UNITED STATES PATENT AND TRADEMARK OFFICE

10/695,806

Dale A. Trsar

Office Action Summary

Fig. 4

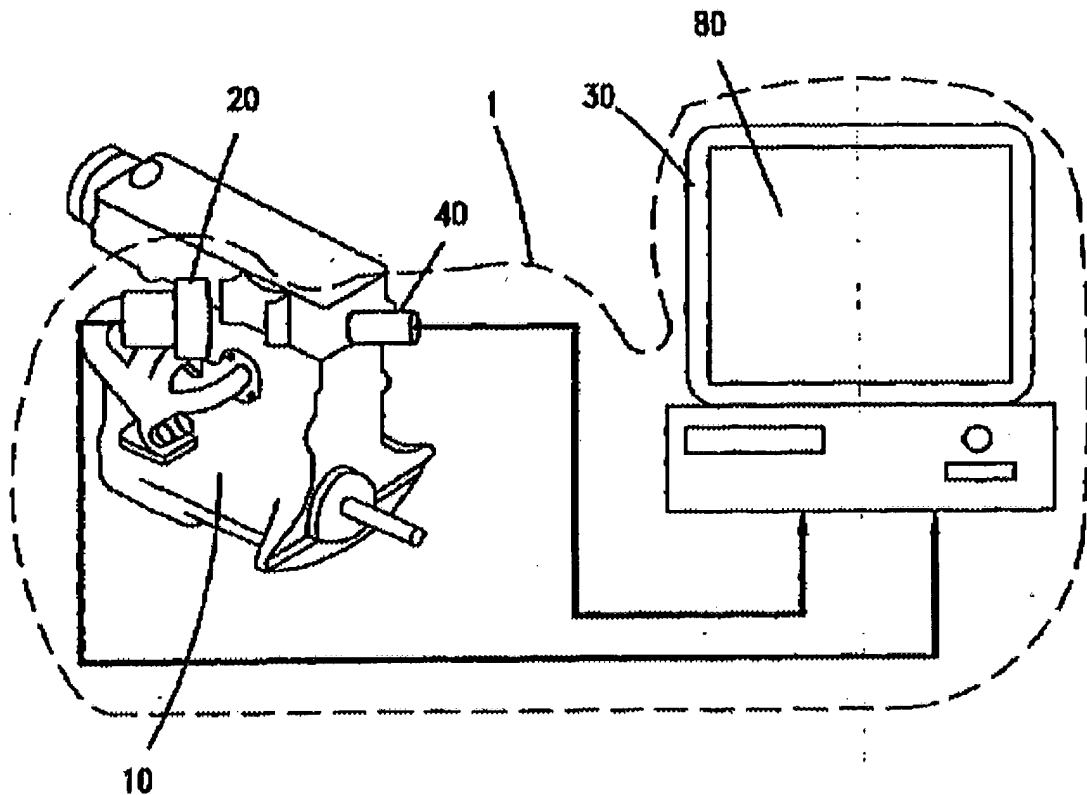
7. The association between the instant claimed invention (independent claims 1,17, and 27) and DeBotton et al. is as follows: as per the claimed displacement measurement device or means for monitoring engine block movement, see the vibration sensor (20) mounted to the engine block (10) of Fig. 4 of DeBotton et al.; as per the claimed signal analyzer or means...for evaluating engine block movement, see the computer (30) of Fig. 4; as per the evaluation of engine cylinder contribution or evaluation of engine block movement, see at least the FFT vibration processing, vibration signature analysis, reference data base construction and comparison

regarding "strong/weak" or "disordered" cylinders of DeBotton et al.; and as per the claimed correlating the engine block movement to the firing order or means for correlating the engine block movement to cylinder firing order, see at least the "triggering transducer" of DeBotton et al. (para. 0144) which may be attached to the spark plug cables (or other points related to firing order) which is used to enable synchronization of the readings obtained from the vibration(displacement) sensor with the angle of the crankshaft.

8. Note that vibration is a known function of displacement/acceleration of engine block (10) and that the vibration sensor (20) of DeBotton et al. may be a "transducer such as an accelerometer, velocity transducer, optical or laser based vibration transducer...being held in place with any suitable, temporary fixing means such as magnets or straps..." (para. 0142)

17. As per dependent claim 12, see at least the computer display of Fig. 4 of DeBotton et al.

18. As per dependent claim 13, see at least the computer processor of the computer 30 of Fig. 4 of DeBotton et al.

20. As per dependent claims 18 and 20, see at least Fig. 4 of DeBotton et al.

22. As per dependent claim 22, see at least the computer display of Fig. 4 of DeBotton et al.

24. As per dependent claim 28, see at least the processor or computer 30 of Fig. 4 of DeBotton et al.

Fig. 2.

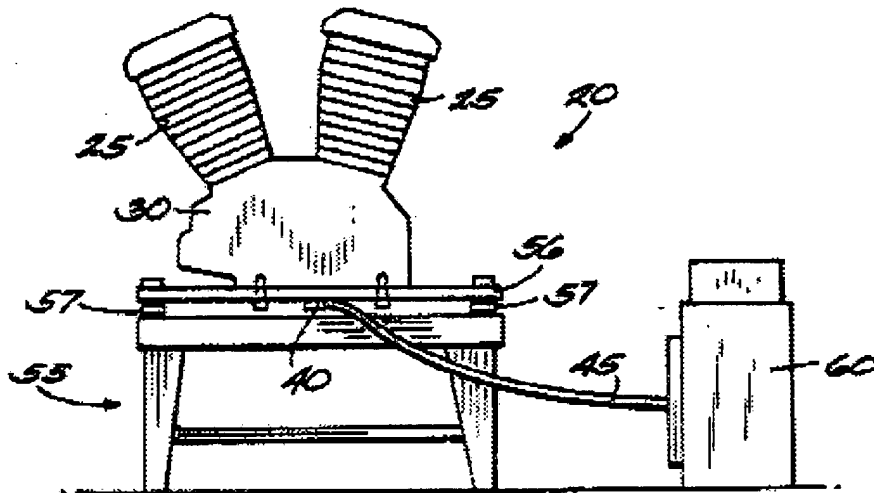
The engine 20 may also be tested when mounted on a test stand 55, as illustrated in FIG. 2, rather than when mounted on a motorcycle 10. The sensor 40 is permanently mounted underneath the test bed 56, which is supported by four rubber isolators 57 (see FIG. 2). Mounting the sensor 40 on the test bed 56 can save an operator time by not requiring a sensor 40 to be installed on the engine 20. The sensor 40 is electrically connected by a wire 45 to a production monitoring system 60.

12. From Fig. 2 (above) and its description, we clearly see vibration (acceleration/displacement) measurements “relative to a stationary structure” which is the test bed 56 and/or test stand 55 of Liang et al.

13. Thus, it would have been obvious to one having ordinary skill in the art at the time the invention was made to combine the “detection of engine block movement relative to a stationary structure” teaching of Liang et al. with the “universal diagnostic method and system for engines” of DeBotton et al. because such a combination provides accurate and reliable (vibration/acceleration/displacement) measurements for diagnostic purposes, and for fine-tuning an engine by accurately balancing all cylinder contributions relative to a fixed position or stationary structure.
